57 17 01 February 8, 2017 **2042955** Supersedes Technical Bulletin V571601 dated January 22, 2016 to include model year 2016 and 2017 applicability.

Front Door(s) May Be Difficult to Close at Temperatures Below Freezing

Figure 4) area where Butyl sealing cord has to be routed

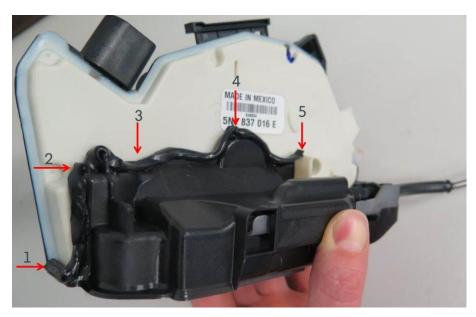
• Carefully route the butyl sealing cord, starting from position 1 (Figure 3, red arrow), along the cap (Figure 4, position 1 to 5) and press it down firmly.

Figure 5: pressing down Butyl sealing cord with suitable tool

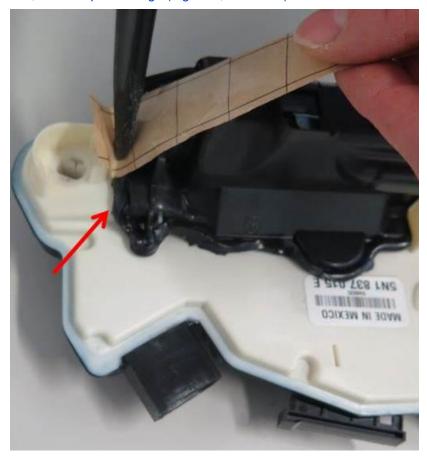
On the driver door lock the Butyl sealing cord must be pressed down in the area of the follower with a suitable tool, for example a wedge (Figure 5, red arrow).
